Project	IEEE 802.16 Broadband Wireless Access Working Group < http://ieee802.org/16 >	
Title	Enhancement Feature for Robust Multimedia Broadcasting	
Date Submitted	[2004-07-15]	
Source(s)	<p>Jungje Son, Jaeweon Cho, Panyuh Joo, Younsun Kim, Beomsik Bae, Yong Chang</p> <p>Samsung Electronics 416, Maetan-3dong, Youngtong-gu, Suwon-si, Gyeonggi-do Korea</p> <p>Min-Sung Kim, Yongjoo Tcha, Yong-Bum Kim, Seong-Choon Lee</p> <p>KT 17 Woomyeon-dong, Seocho-gu, Seoul, 137-792, Korea</p>	<p>jungje.son@samsung.com jaeweon.cho@samsung.com panyuh@samsung.com younsun@samsung.com bsbae@samsung.com yongchang@samsung.com</p> <p>Voice: +82-31-279-5098 Fax: +82-31-279-5130</p> <p>cyberk@kt.co.kr Voice : +82-2-526-6109 Fax : +82-2-526-5200</p>
Re:	This contribution is for reply of IEEE P802.16e/D3 recirculation.	
Abstract	This contribution proposes the physical enhancement feature for robust multimedia broadcasting service. This is the harmonized contribution related to multimedia broadcasting service among comment #336, #342 and #417 (referring to C802.16e-04_193, C802.16e-04_195r1 and C802.16e-04_169)

Enhancement Feature for Robust Multimedia Broadcasting

Figure 1. Time multiplexing for OFDMAThe multi-subpacket transmission scheme

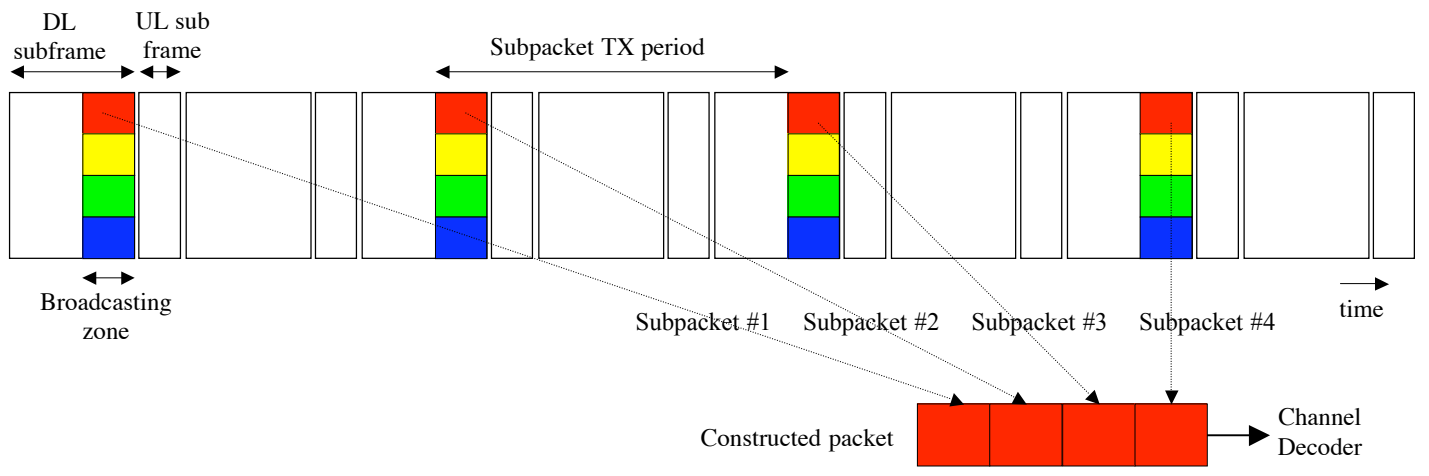
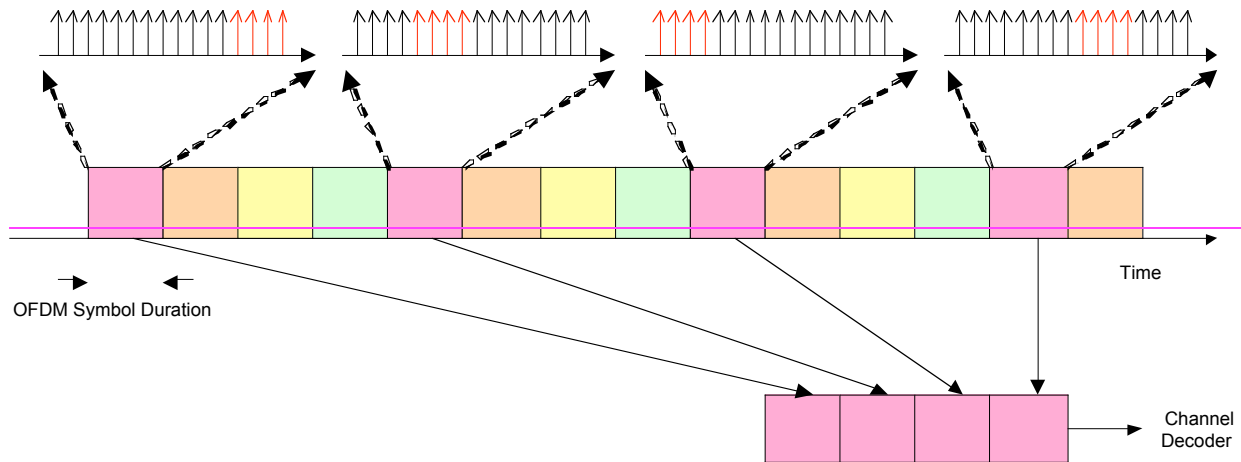
In this contribution, ~~as shown in figure 1,~~ we propose the ~~way~~ BS transmission scheme of ~~+~~ multimedia broadcasting traffic ~~to exploit~~ time diversity. ~~In the proposed scheme, the encoded packet is divided into multiple subpackets and each subpacket is transmitted in different frame so as to go through different fading channel. MS collects and concatenates these subpackets, and then the constructed packet is decoded at the channel decoder. Figure 1 depicts the proposed multi-subpacket transmission scheme. The example shown in this figure is for the case that the packet is divided into 4 subpackets and the transmission period of subpacket is 2 frames. Time-multiplexing is the scheme that divides the coded symbols from encoder into multiple symbols and transmits each during discontinuous time interval.~~
